PLANNING BOARD

Tuesday, July 22, 2025 at 4:30 PM
Room 24 (Ground Level of City Hall) and
Zoom

To: Chair Brandon Mazer & Members of the Planning Board
From: Andrew Graminski, Planning & Development Review Manager
Date: July 18, 2025
Re: 1125 Brighton Avenue
Project ID: PL-003379-2025
CBL: 269 B001001
Meeting Date: July 22, 2025

Drawing No.
C-4.0

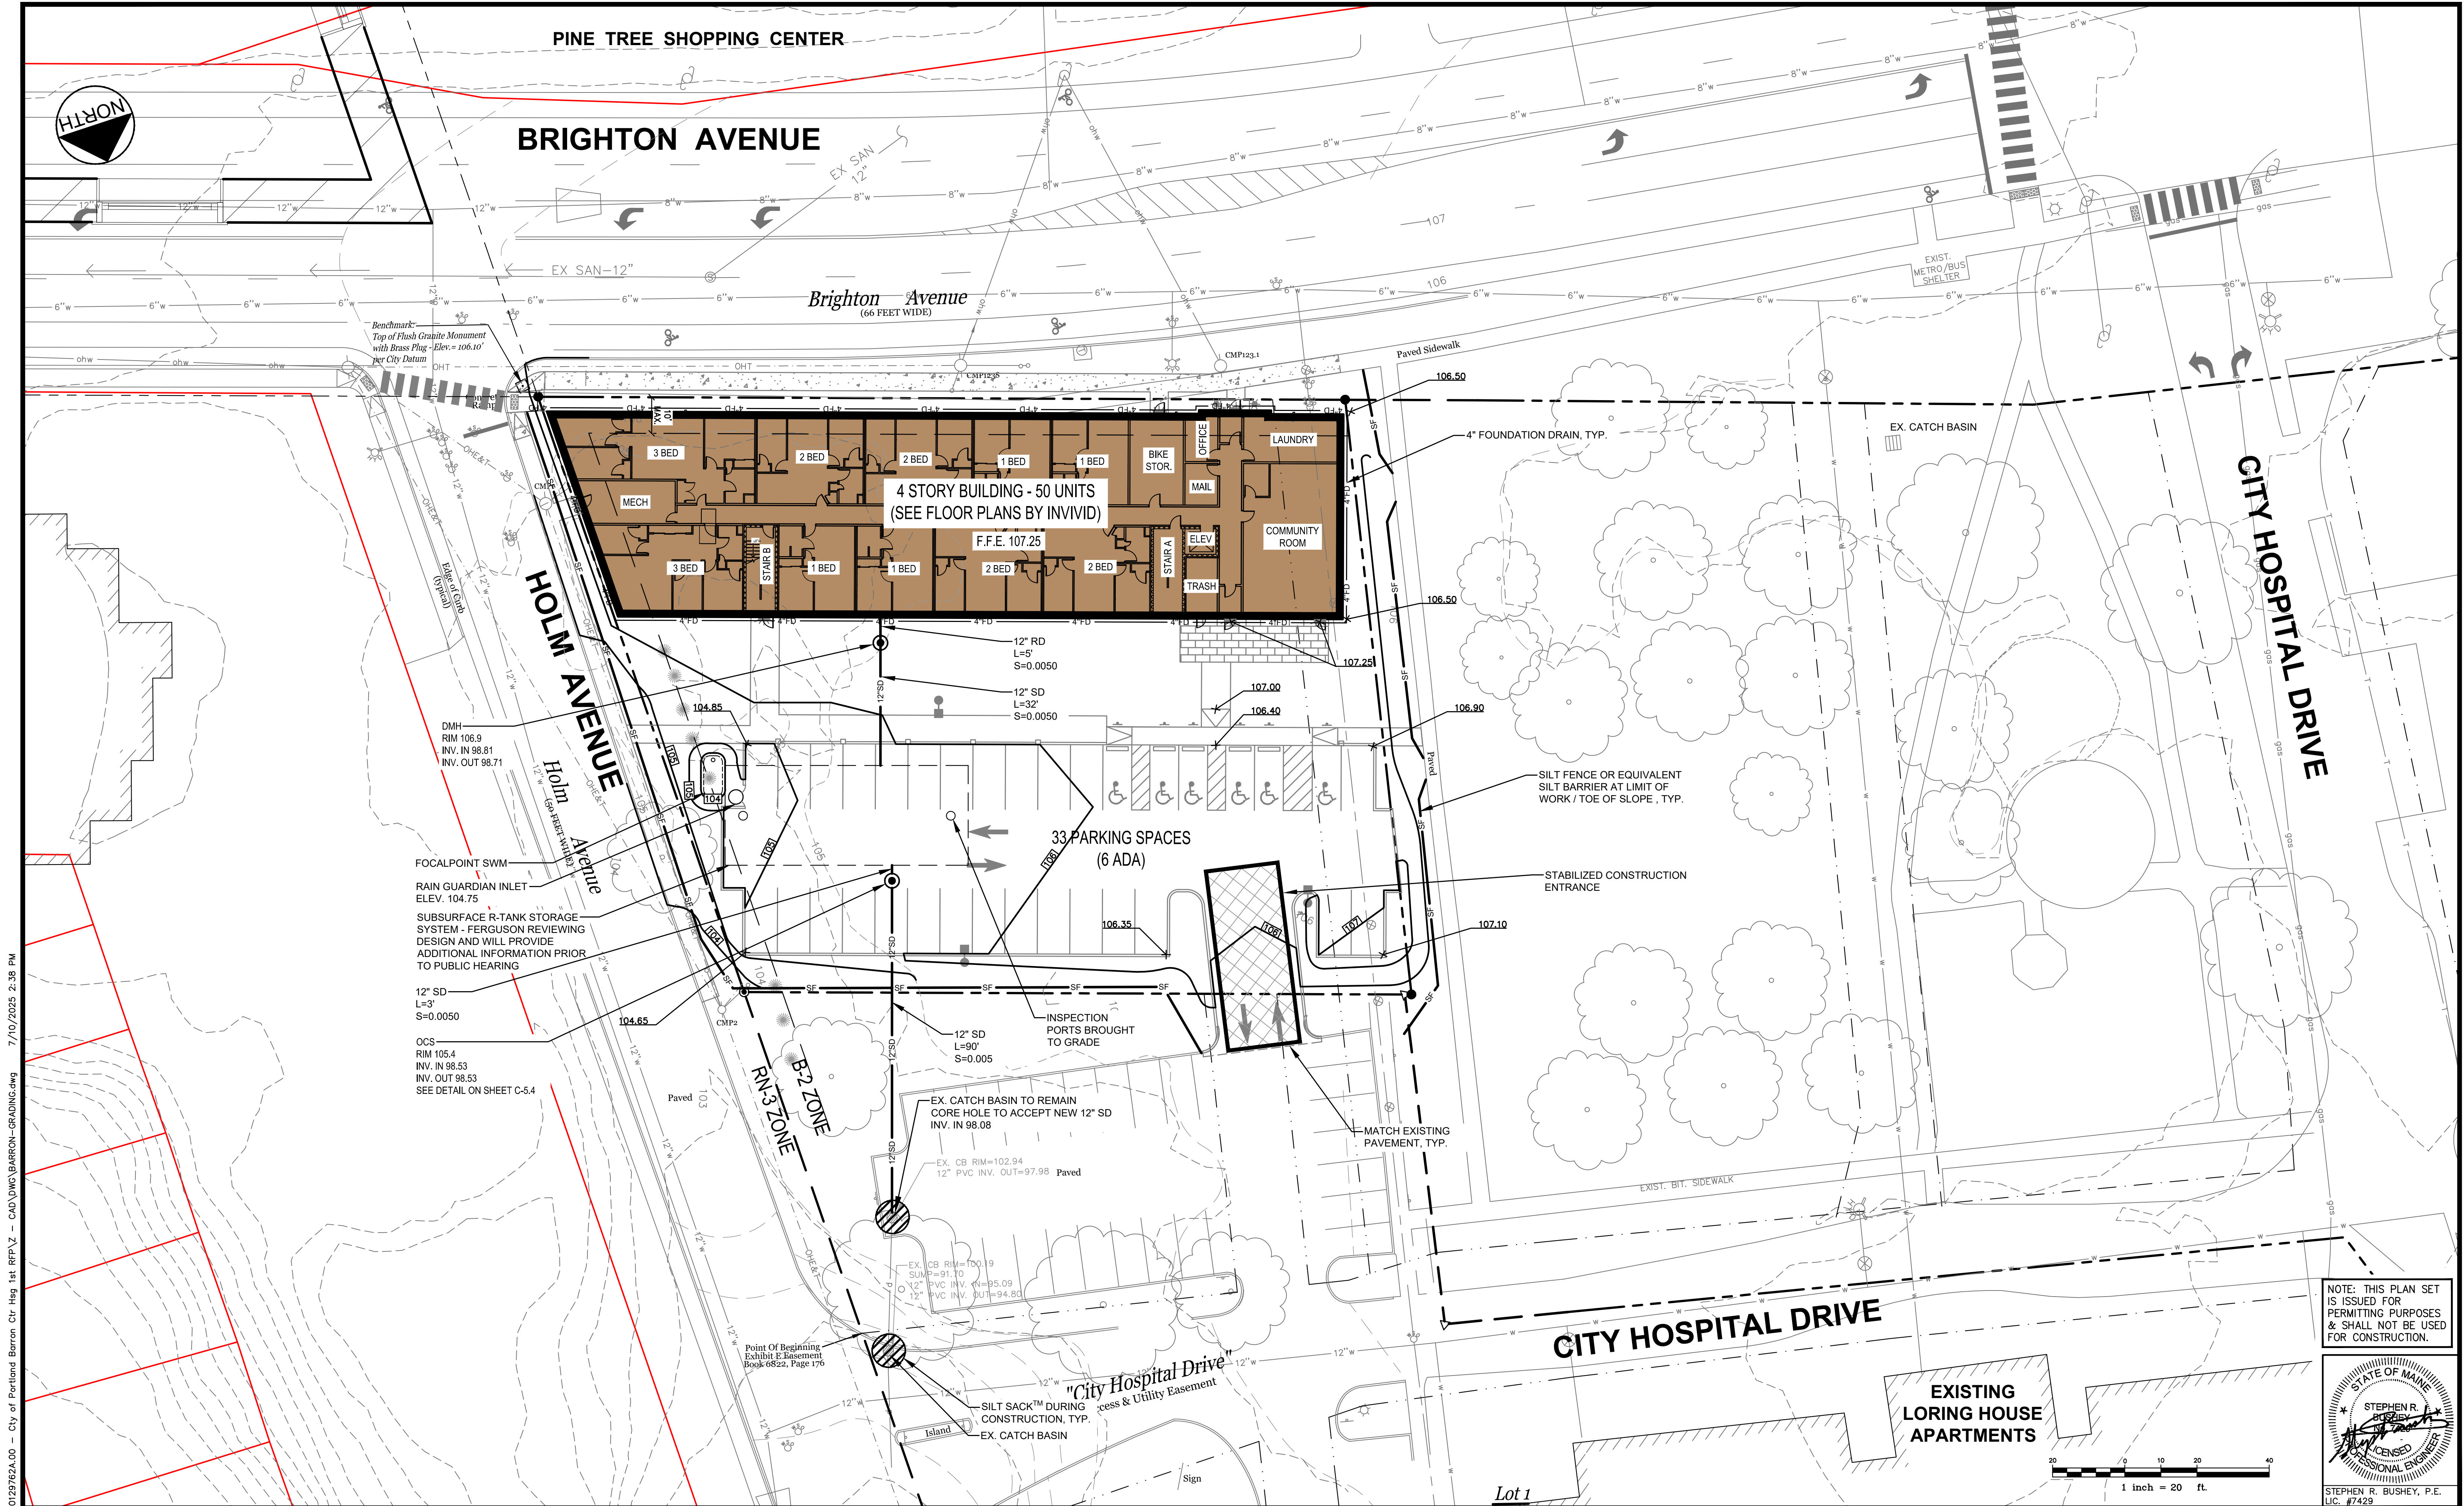
- *Drawings C-40 (Grading, Drainage & Erosion Control Plan) do not show proposed topography or elevation information for the proposed drainage infrastructure.*

- Drawing C-4.0 is provided as the Grading, Drainage & Erosion Control Plan. No proposed topography or elevation information for proposed drainage infrastructure has been provided on this drawing. Details should also be provided for the proposed subsurface stormwater systems.

- Sheet C-4.0 - There is very little detail on this grading sheet, no spot grades are provided. Spot Grades and slopes shall be added to the plans for proposed improvements.
- DPW Water Resources

C508

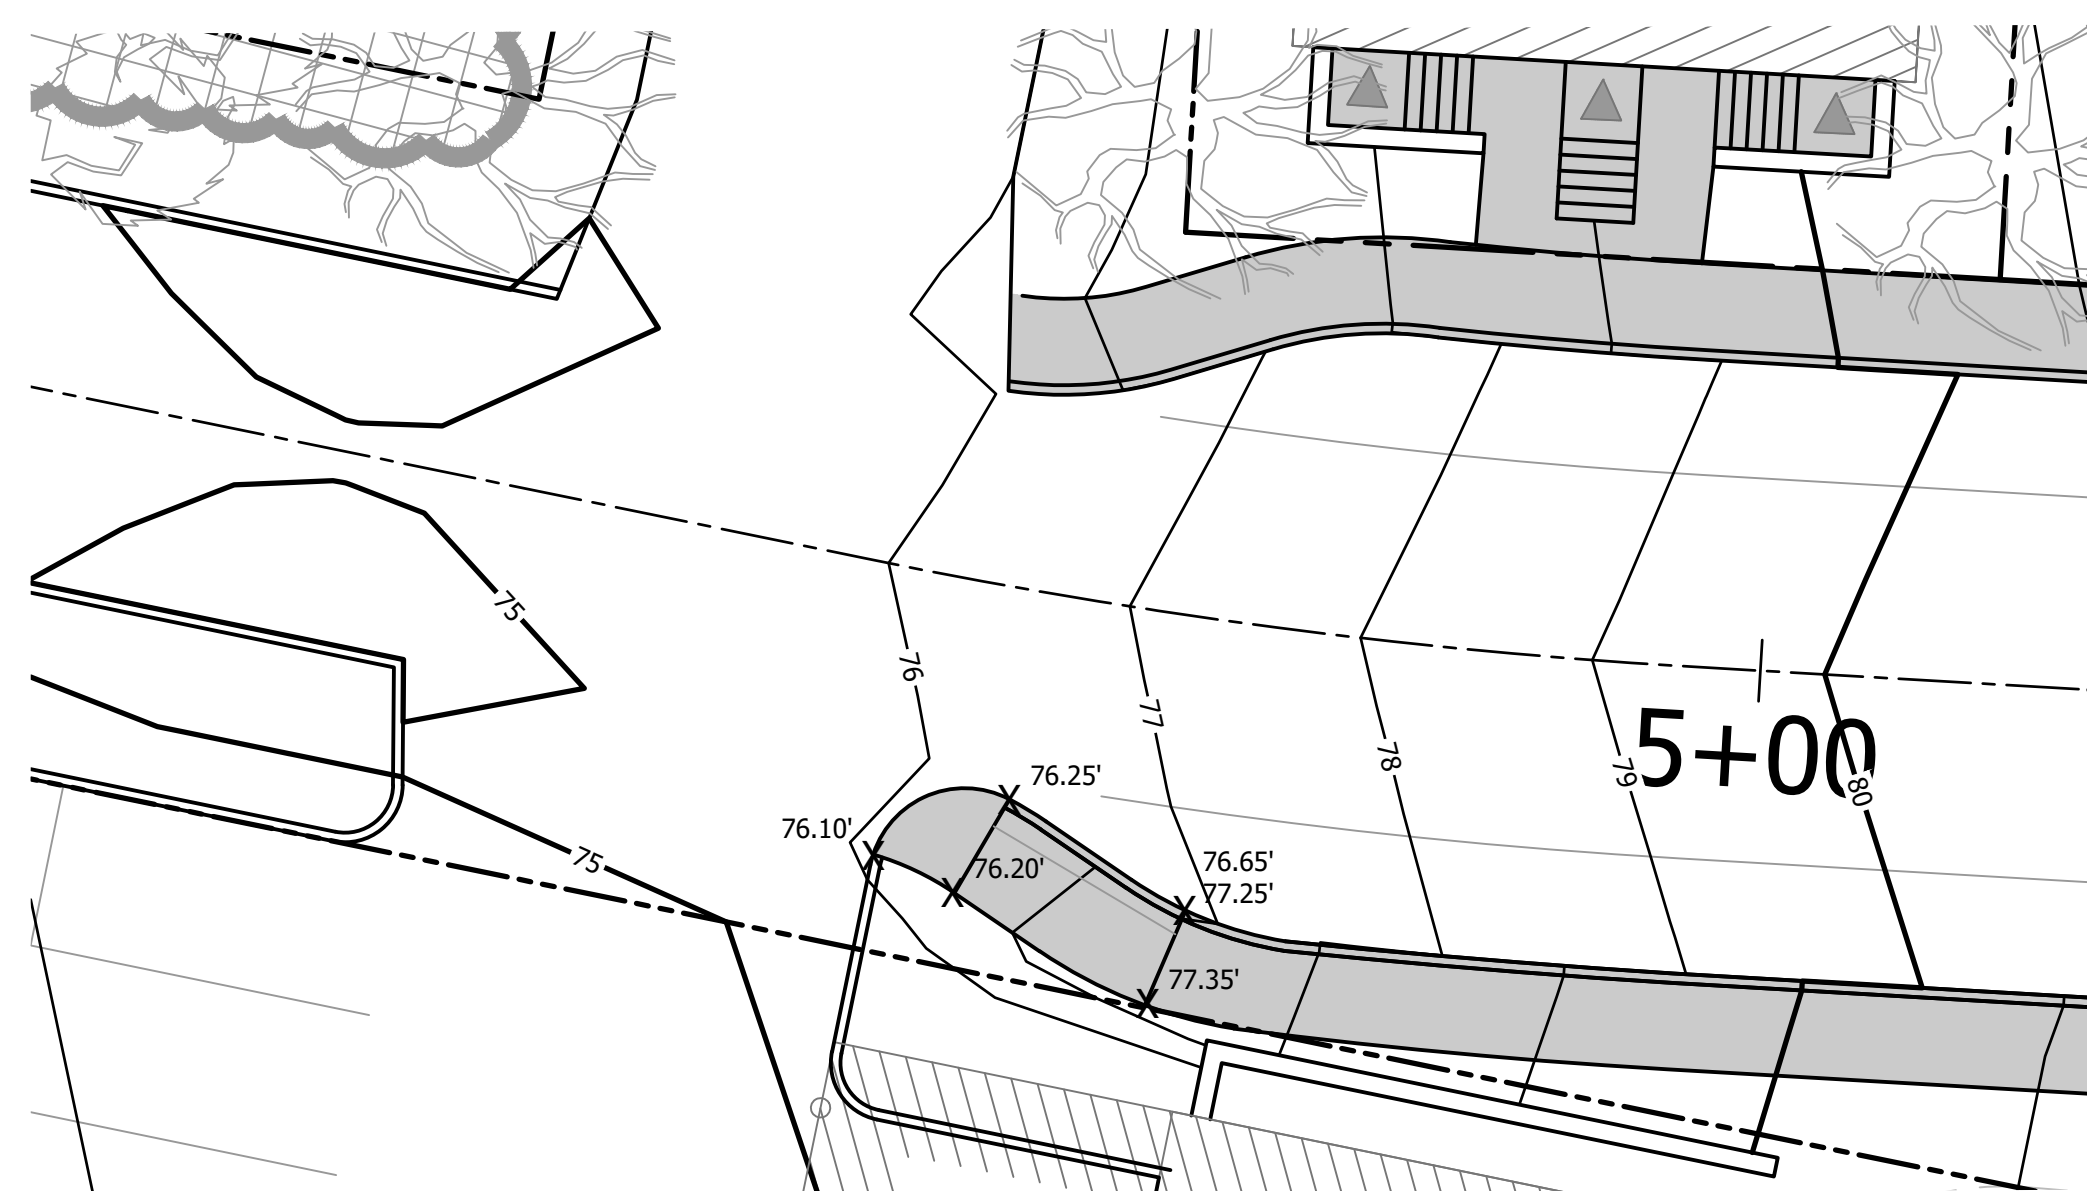
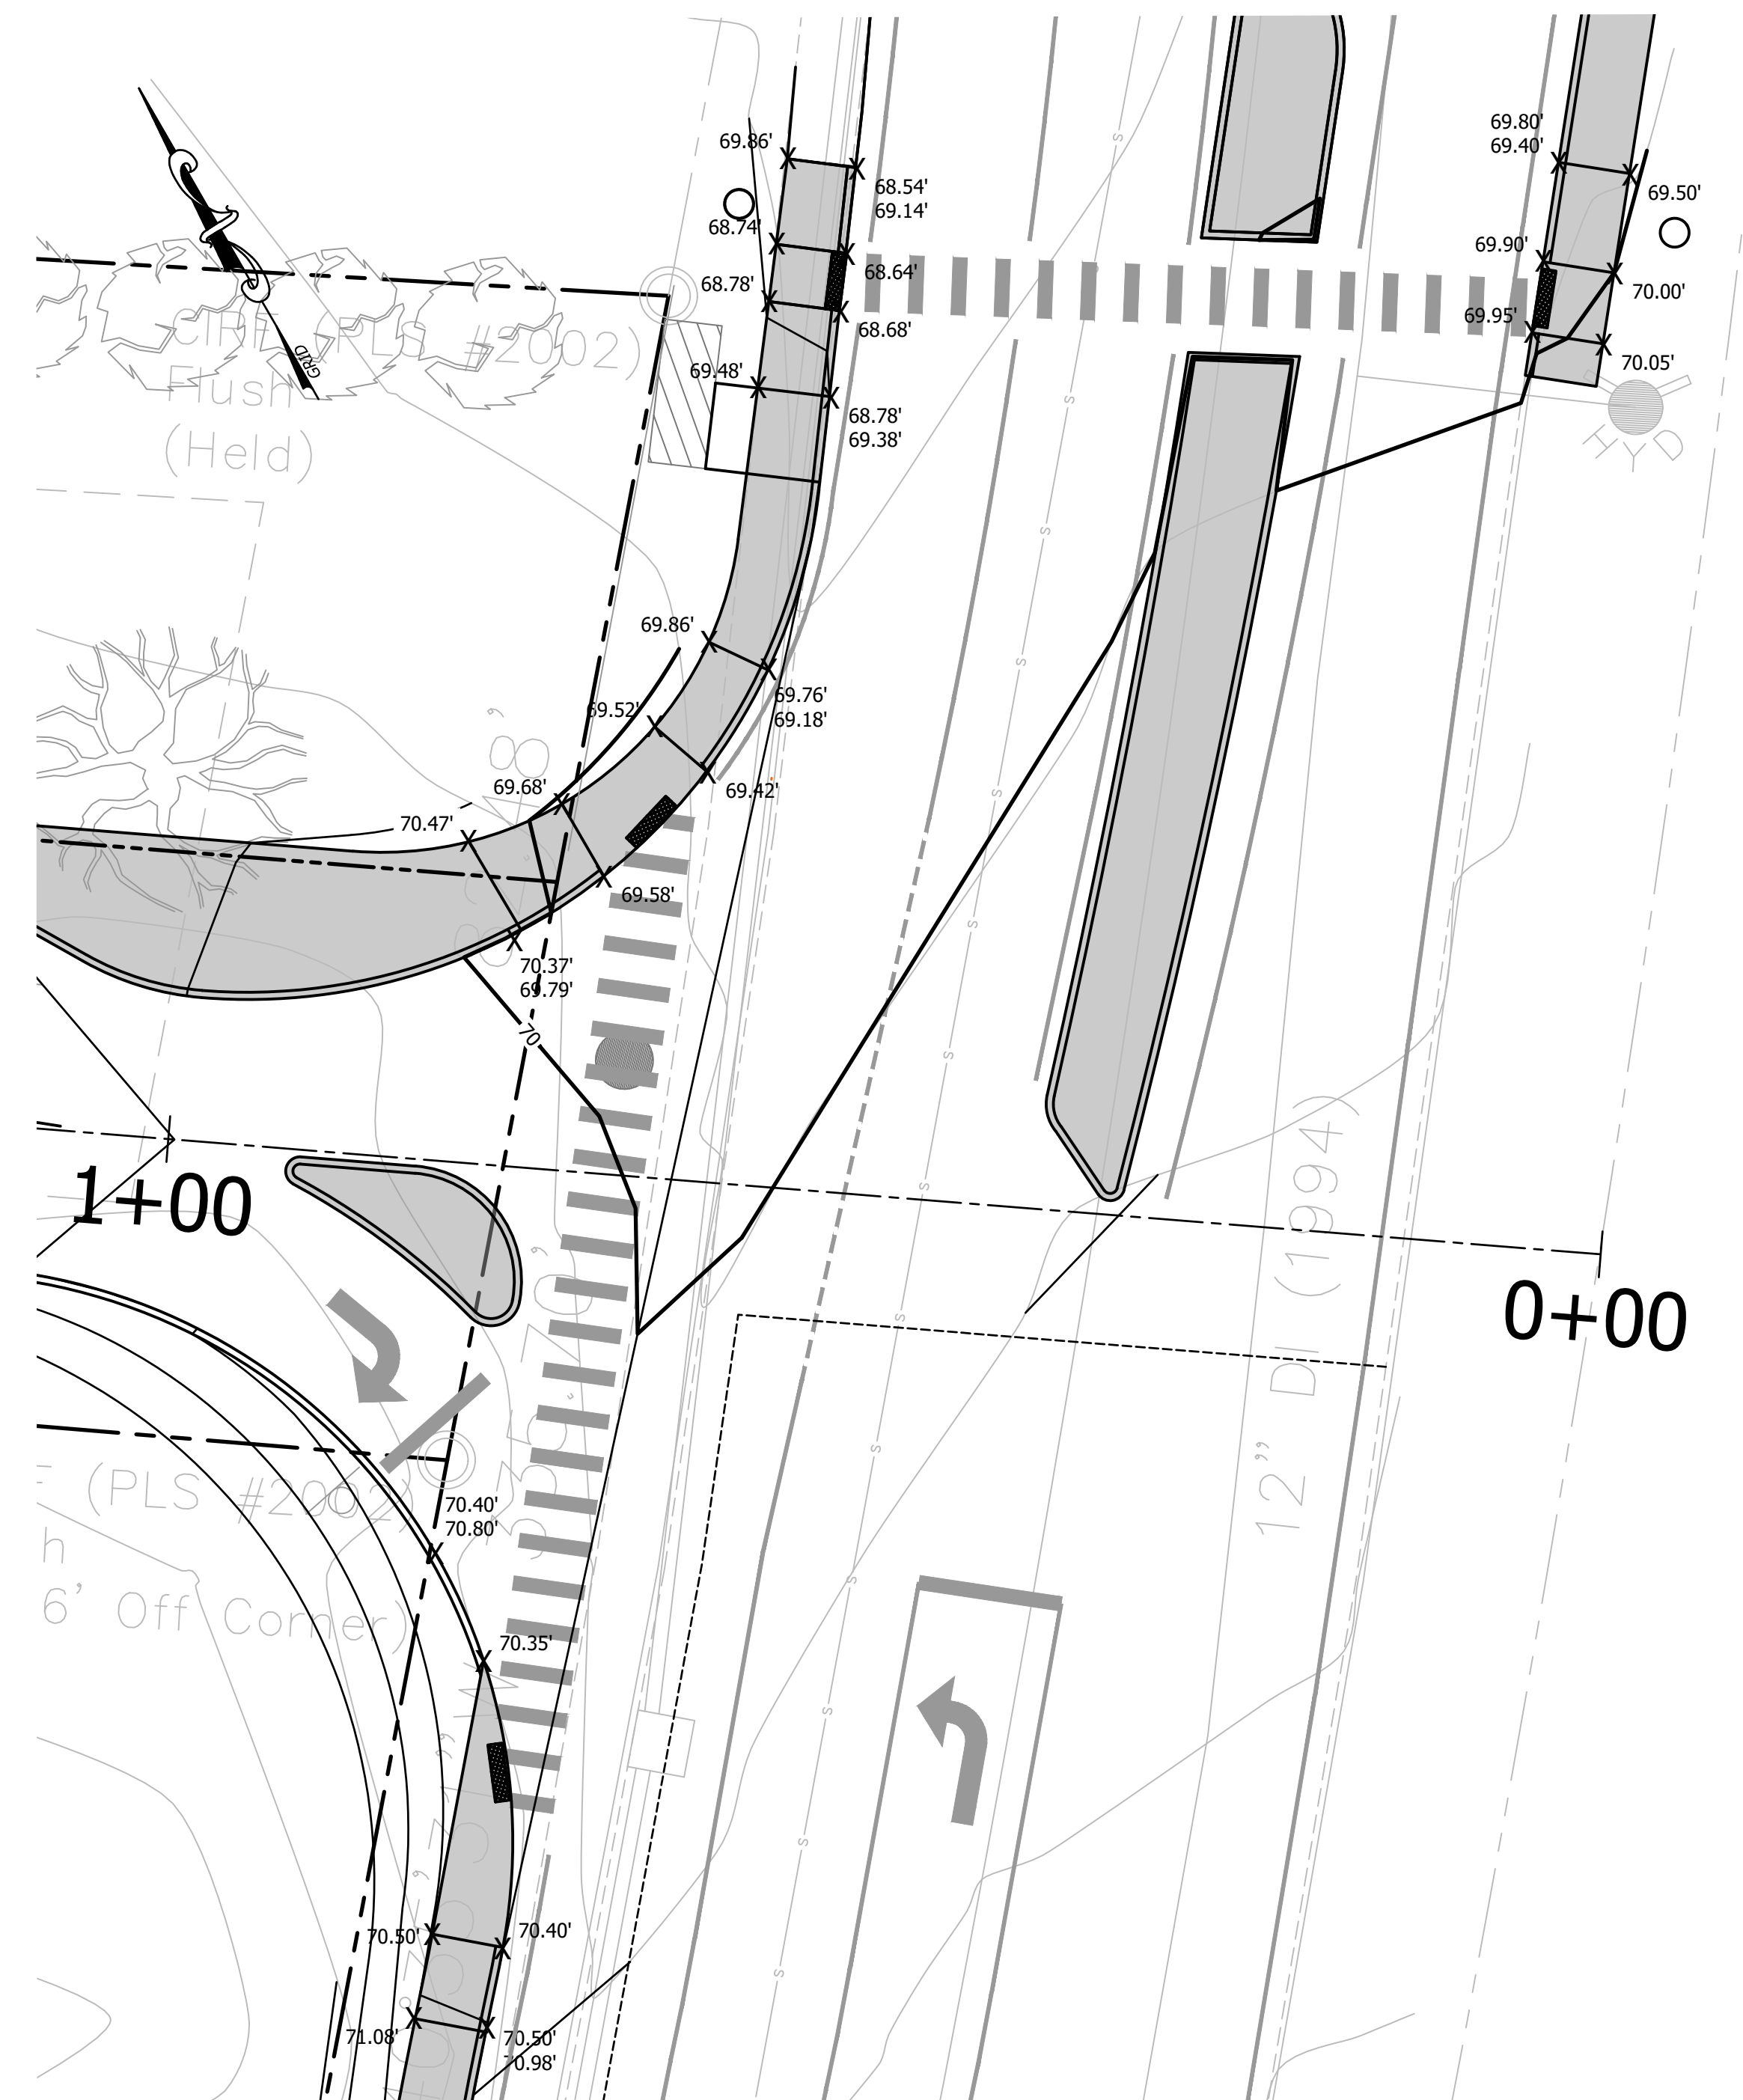
- C105 - Spot grades and slopes shall be added to plans for proposed improvements within the ROW at grade breaks for proposed driveways, pedestrian ramps, accessible crossings, sidewalks and at the end of the limits of the proposed improvements for the property.
Spot grades are detailed on detail sheet C508
